Minor Amendments Supporting Document

Below is a table highlighting all minor amendments proposed as part of the NMA submission, along with their previously approved drawing & number, and the proposed amended drawing & number.

Proposed Car Park Sections – 254173-LPP-90-SW-L00-DES-L-0106-P3

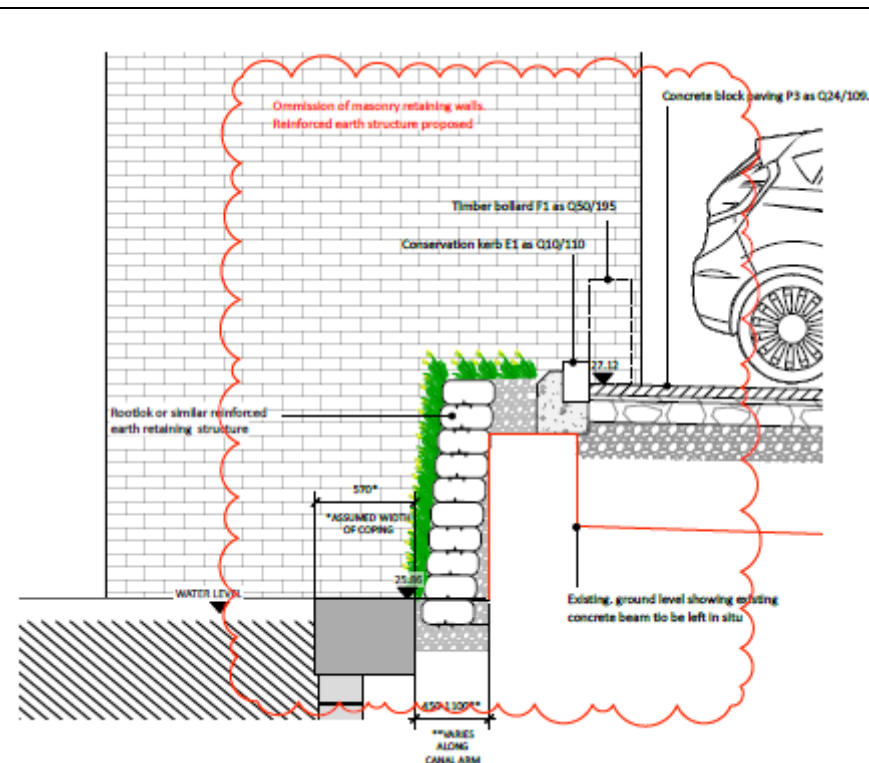
Minor Amendment	Approved Drawing	Approved Drawing No.	Proposed Drawing	Proposed Drawing No
1) Car Parking An uplift in levels is proposed to the southern edge of the car park, in order to simplify the drainage strategy, omitting the need for multiple channel drains within the footprint of the viaduct as previously proposed, and instead relying on the single channel drain running parallel. The increase in levels has identified further opportunities to retain a greater amount of residual material on site that would otherwise need to be taken off site. This vastly improves the sustainability of the site by reducing the number of lorry / vehicle loads of earth to be removed from the site. The change in level along the southern edge of the carpark is an average of 493mm increase on the levels approved as part of the previous NMA application (118024/NMC/2017). The levels along the northern edge of the car park remain the same. The revised retaining structure to the southern edge of the car park will consist of Rootlok (or similar reinforced earth structure) which will soften the appearance of the structure, allowing it to become part of the landscaping of the site boundary, and therefore reducing its visual impact on the viaducts.	Proposed Site Plan	16042-A0750-c3	Proposed Site Plan	16042-P0750-A

The above comparison highlights the improved retaining edge of the car park where the levels have been increased. The proposed Rootlok (or similar reinforced earth structure) will not require any maintenance.

Proposed Drawing - 254173-LPP-90-SW-L00-SEC-L-0301-P3

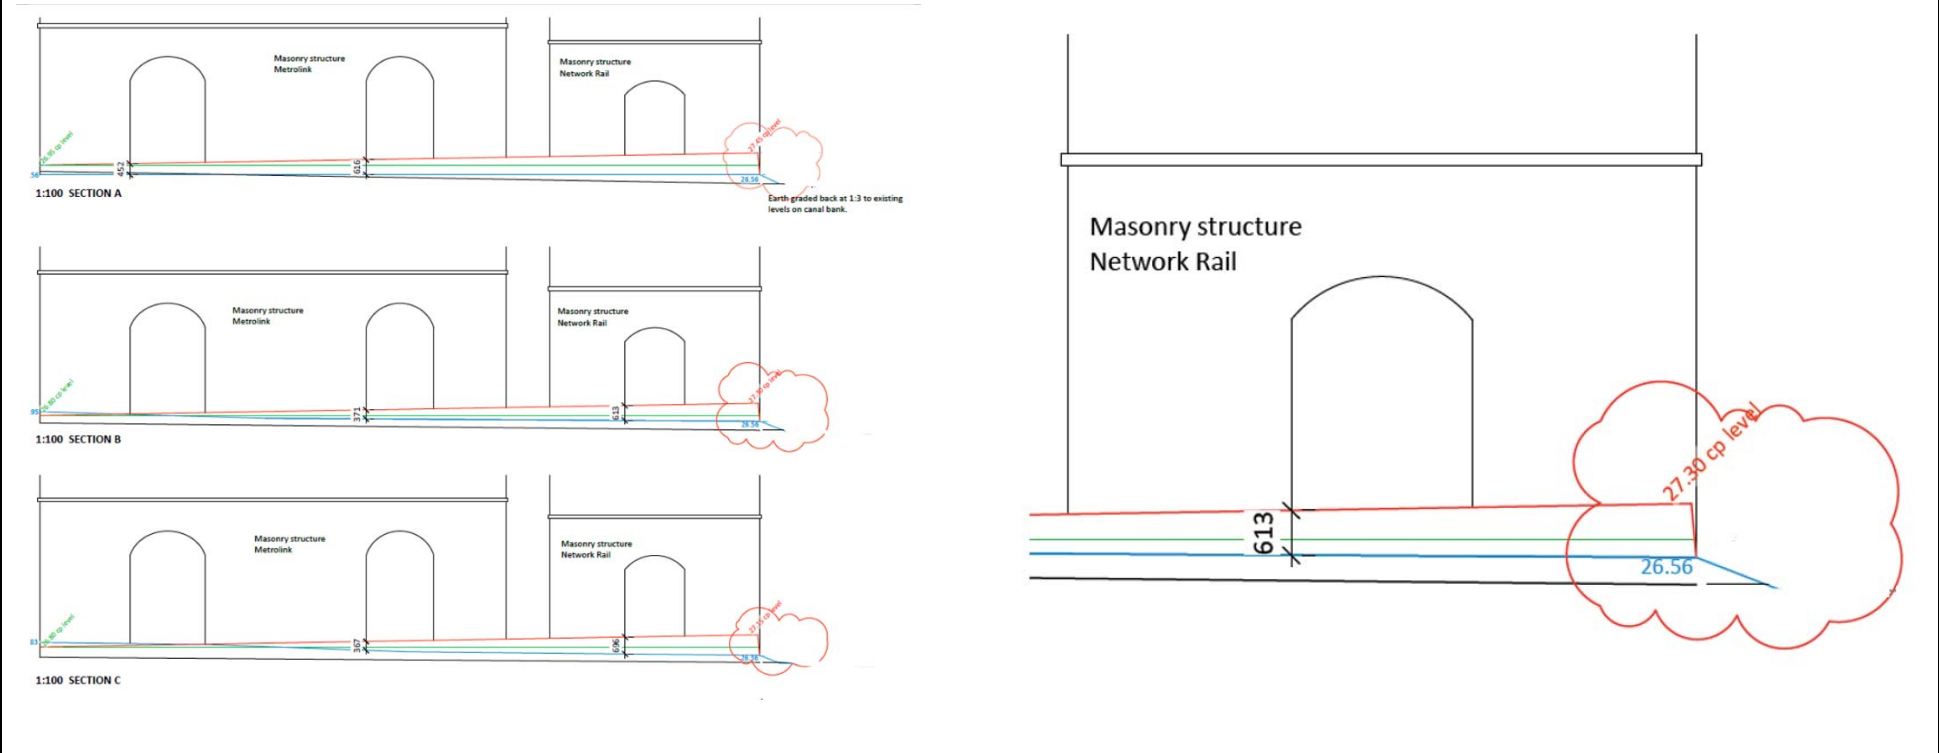
The above extract drawing 254173-LPP-90-SW-L00-SEC-L-0301-P3 highlights the changes in level between the previously approved application 109335/FO/2015/C1 (the lines shown in **GREEN**) and the proposed revised levels as part of this application 125388/NMC/2019 (the lines shown in **RED**). These show that the levels increase no more than 500mm at any point, from those approved to those proposed.

The view of the viaducts is retained & the increased levels will have no impact on this.

Proposed Drawing - 254173-LPP-90-SW-L00-DET-L-0200-C1

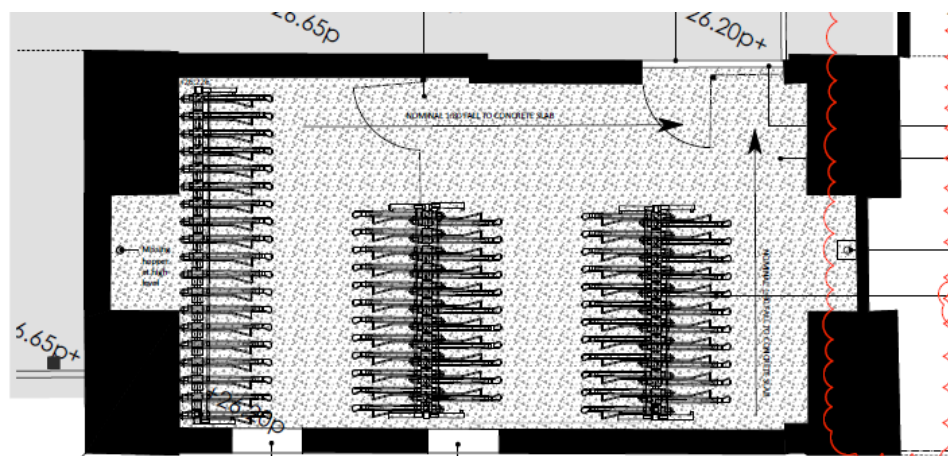
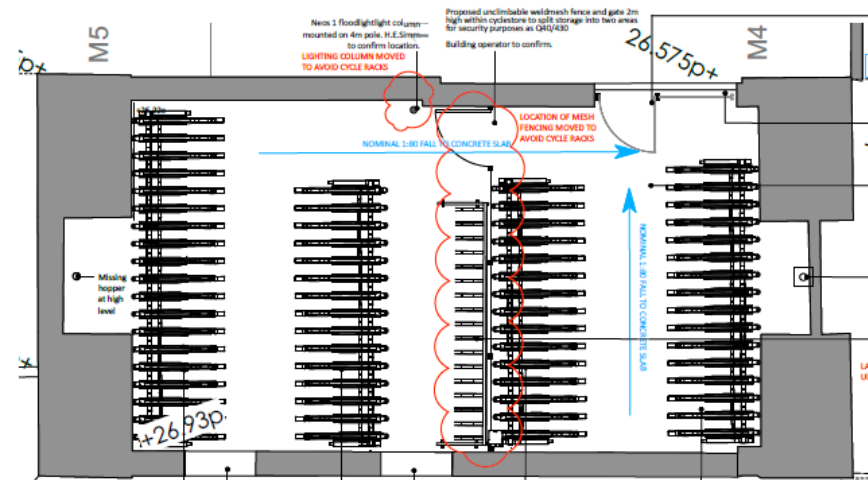
2) Viaduct Cycle Store The internal layout of the cycle store has been amended to avoid any clashes between the cycle racks and the internal security fence.	Viaduct car parking fencing and walling	254173-LPP-95-L00-DET-L-0214-T3	Viaduct car parking fencing and walling	254173-LPP-95-L00-DET-L-0214-P1
	Viaduct Cycle store	254173-LPP-90-SW-L00-DET-L-0200-T2	Viaduct Cycle store	254173-LPP-90-SW-L00-DET-L-0200-C1

The above drawings highlight the changes between the two designs for the viaduct cycle store. The proposed alteration seeks to improve the space & provide a safer & more secure environment for storage.
